SUNDRY NOTICES AND REPORTS ON WELLS  Do not use this form for proposals to drill or to deepen or reentry to a different reservoir.  Use "APPLICATION FOR PERMIT - " for such proposals 25 Fight 1977		5. Lease Designation and Serial No.
		SF-078194
Use "APPLICATION FOR F	PERMIT - " for such prophes 25 AMII: 4/	6. If Indian, Allottee or Tribe Name
	070 FARMINGTON, NM	7. If Unit or CA, Agreement Designation

#### Ludwick LS # 23 PXA Procedures

Re: Permanent Abandonment

Well: 23 Ludwick LS

# LUDWICK LS 023 Location — 19D— 30N—10W SINGLE pc ORIG.COMPLETION — 12/65 LAST FILE UPDATE — 6/92 BY CSW

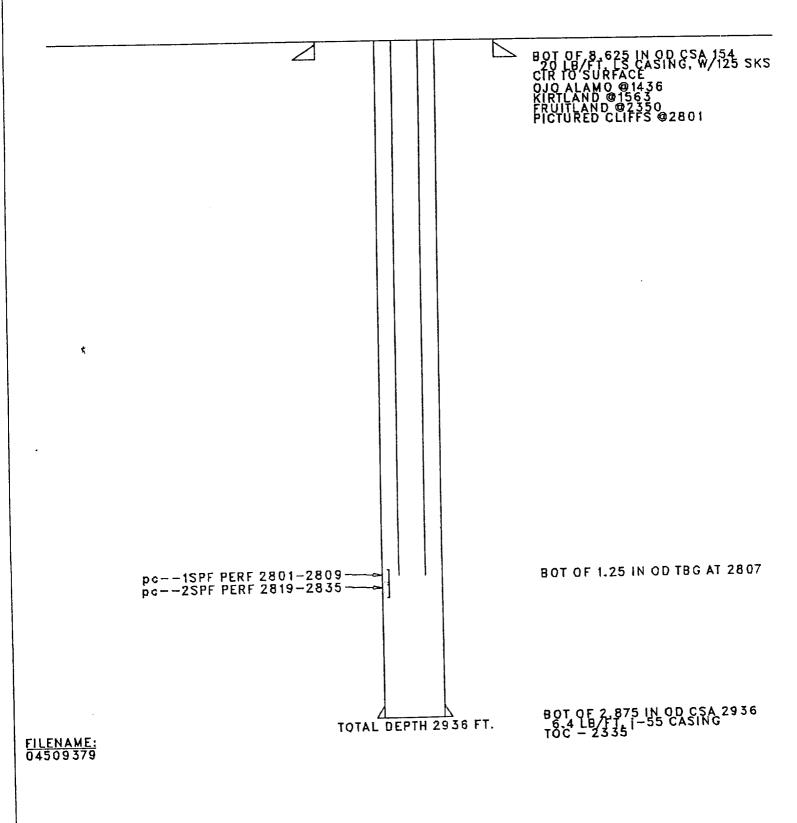
At a Minimum, after first plug for PC & Fruithod!

1) Perforate a 1613', Place a cement plug from
1613' to 1357' inside & outside the casing
Plus 100% excess cement in the annulus and
50 Linear Feet excess in the casing. (Oso Alamo 1563' to
1907')

2) Perforate a 204' and circulate cement to
the Surface. (Surface Cas. a 15%)
